### **Whale Tail Open Pit - 2020 Annual Inspection**

## **RE: Amaruq Mine - Whale Tail Open Pit - 2019 Annual Inspection**

### **Amaruq Project - Whale Tail Open Pit - 2020 Annual Inspection**

## Groundwater

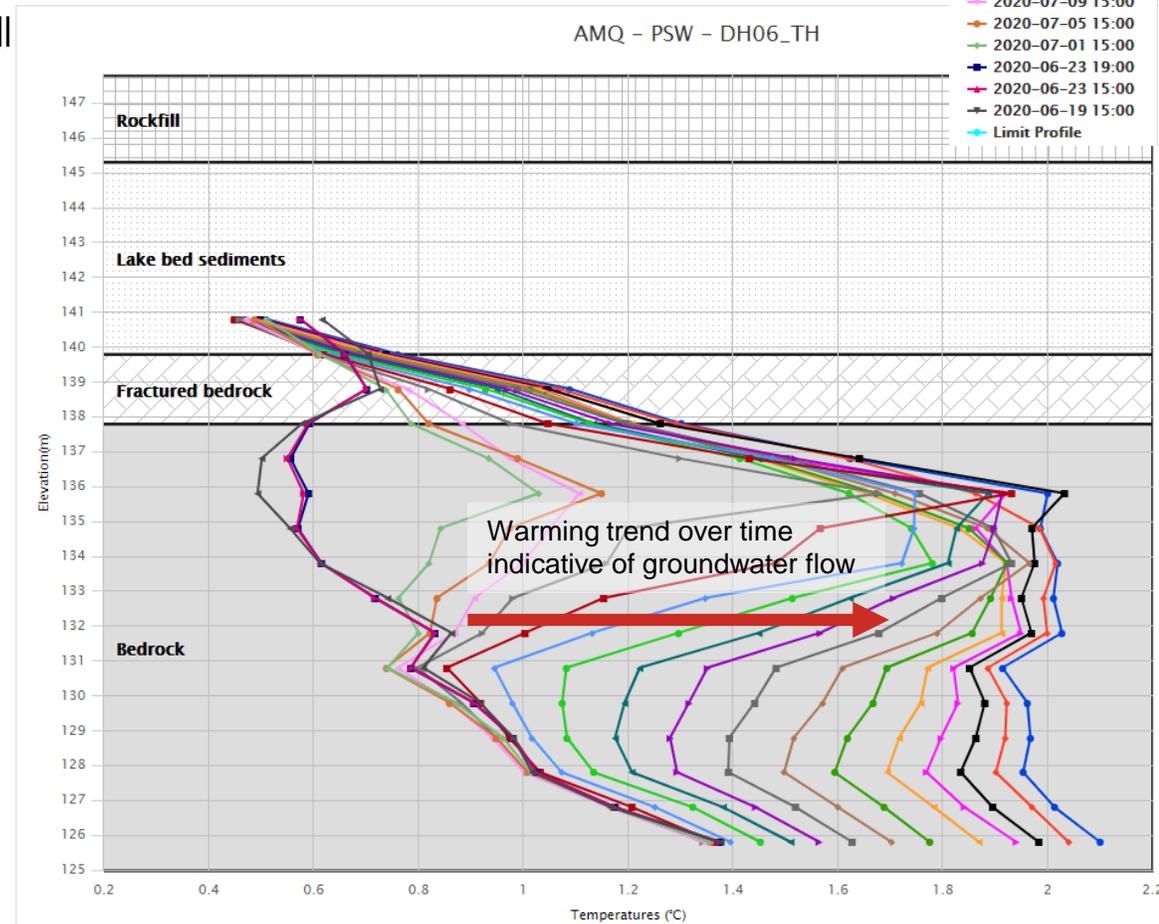
- The talik/cryopeg is predicted to extend approximately 100 to 150 m below surface in the south wall of the open pit. It is expected that groundwater will continue to enter the pit within the talik/cryopeg as mining progresses.

- As the open pit deepens, the groundwater will eventually manifest as seepage in the wall rather than in the floor of the open pit. This may not occur until the floor of the pit passes below the base of the talik/cryopeg but could occur earlier due to a change in the rock mass characteristics (e.g. the rock mass quality in the diorite is expected to improve at approximately 80 m below surface).

## October

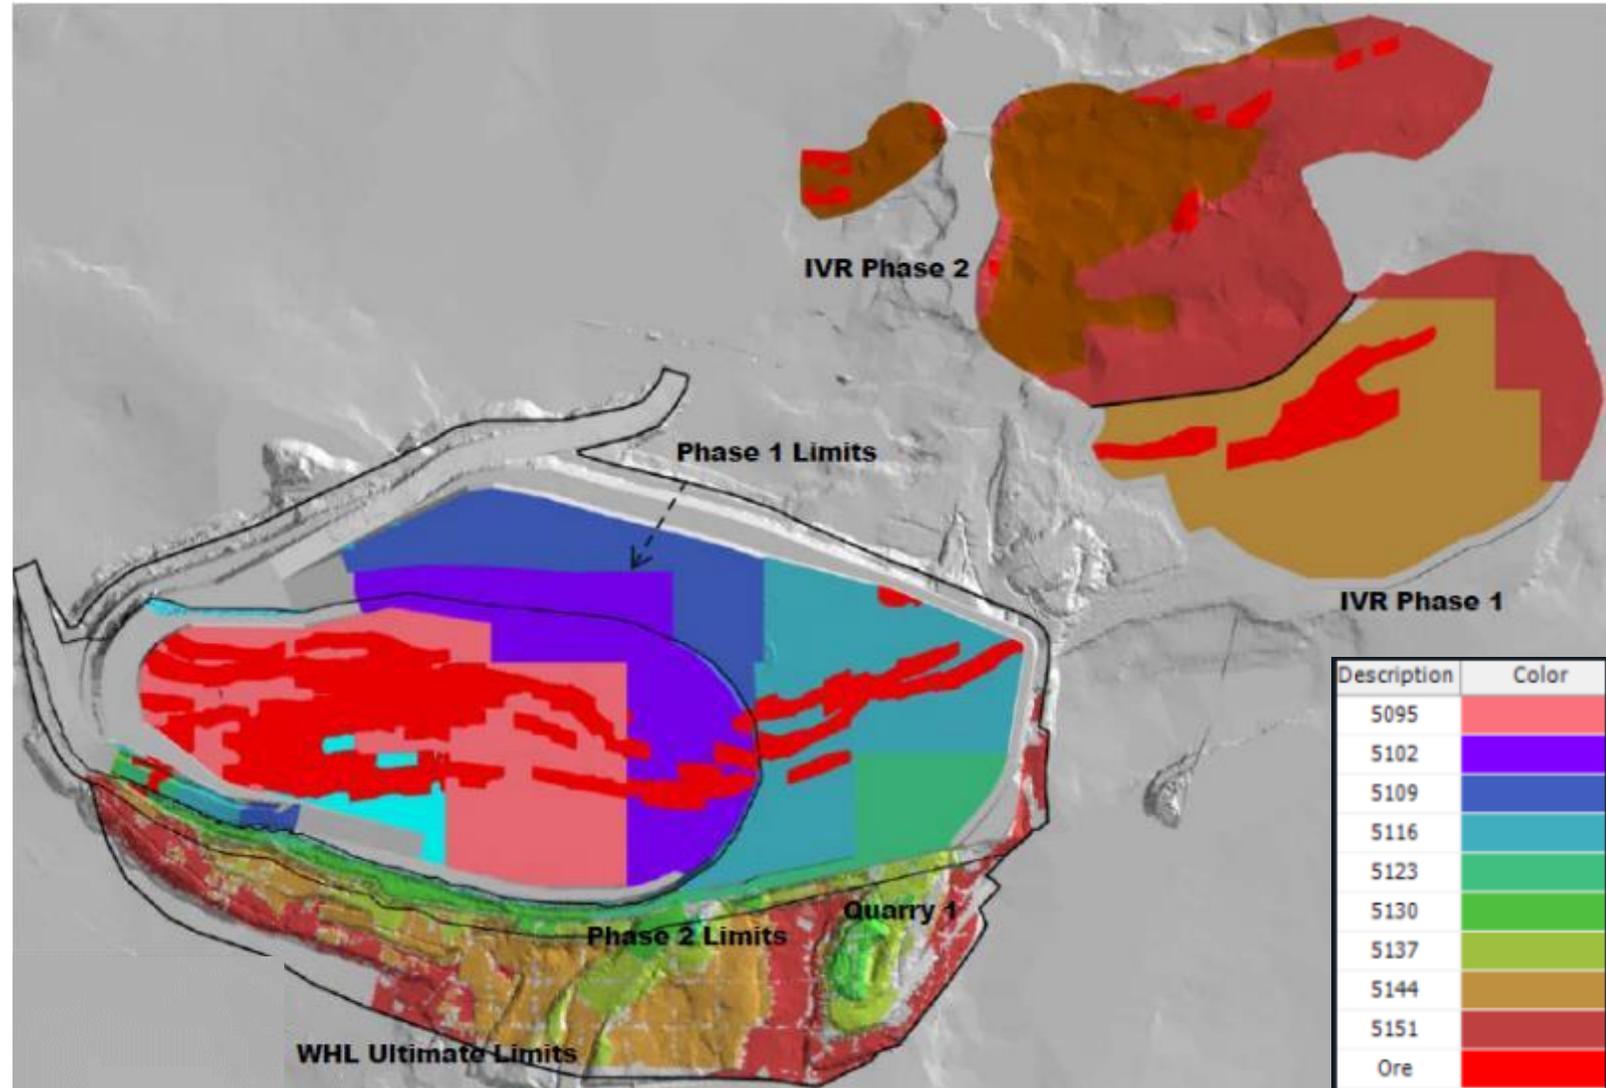
- Continuing to deepen Phase 1 and expanding to the northeast within Phase 2 at Whale Tail.
- Management of the Komatiite in the north wall of Phase 1 is expected to be an on-going consideration.
- It will be important to monitor the performance of the benches on the northeast corner of Phase 2 (Design Sector D4)
- It will be important to continue to monitor groundwater inflows to the open pit as Phase 1 deepens.
- Excavation of the initial benches in IVR Phase 1 continues. This provides an opportunity to review the rock mass characteristics and bench performance.

## November

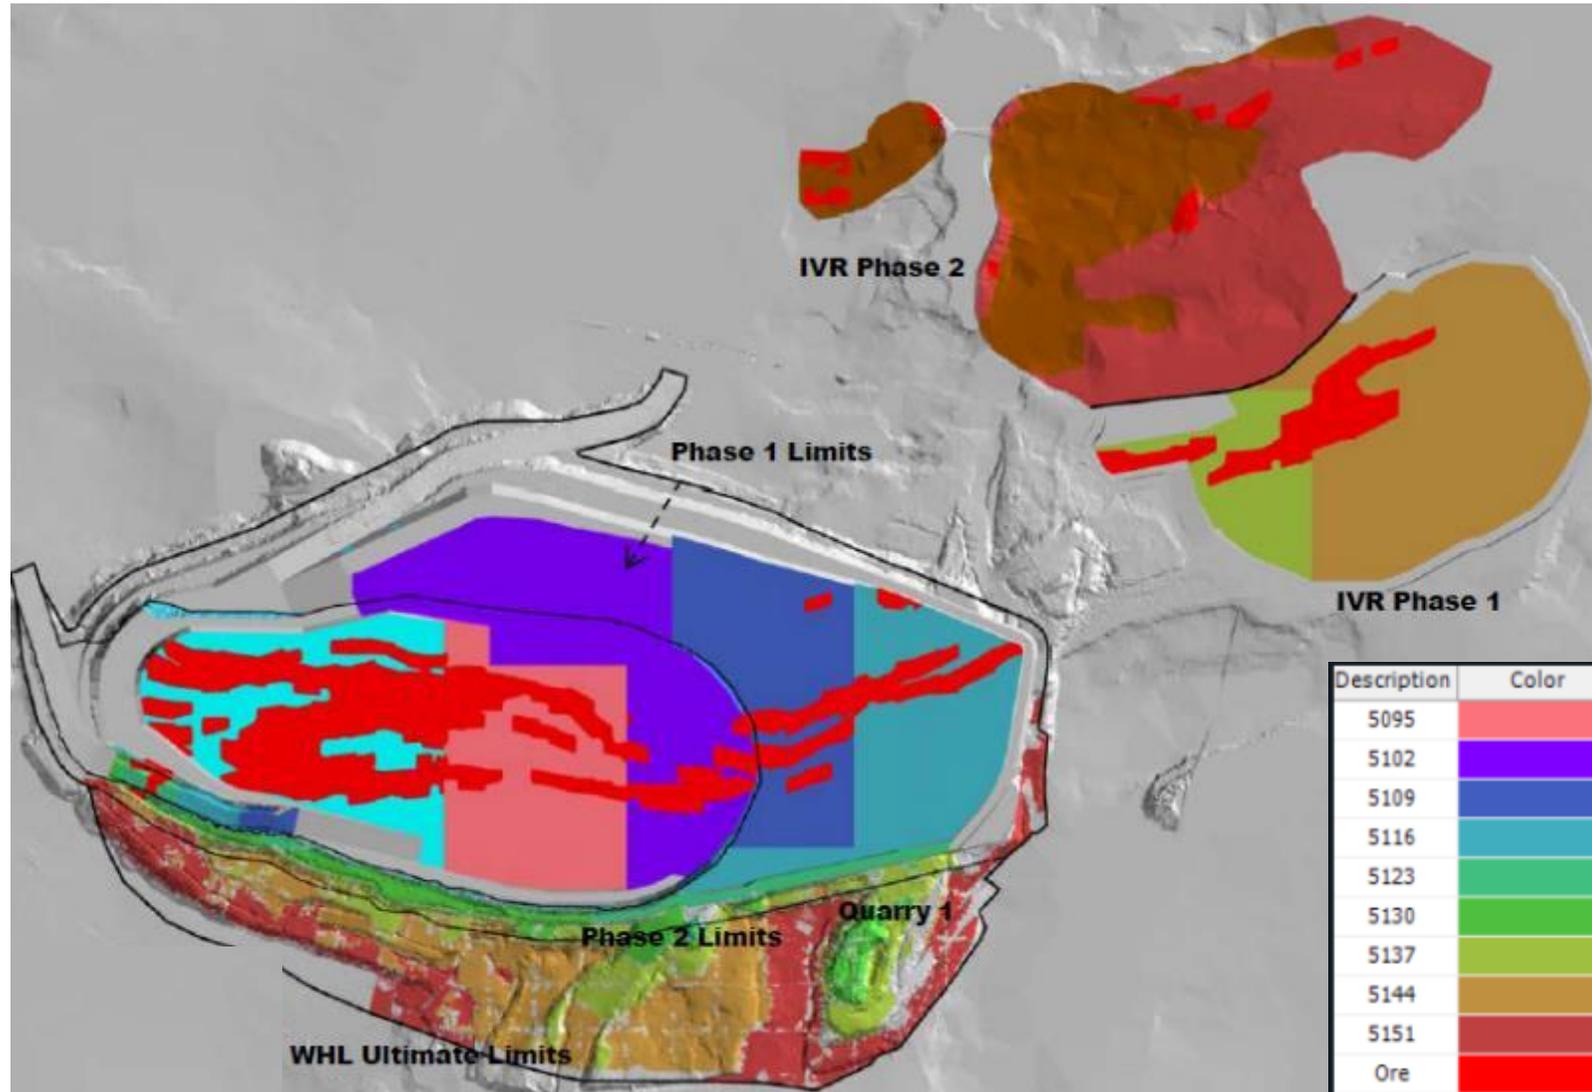
- Expanding Phase 2 to the North and East.
- Management of the Komatiite in the north wall of Phase 1 is expected to be an on-going consideration.
- The push back to the north reduces the exposure of Komatiite in the Phase 1 north wall and is favourable.
- Continued mining in the north and southeast of Phase 2 provides new opportunities to confirm the position of the Ramp Fault.
- Excavation of the initial benches in IVR Phase 1 continues. This provides an opportunity to review the rock mass characteristics and bench performance. The footwall (north wall) of the pit is of particular concern due to the expected presence of several faults and brittle structures.
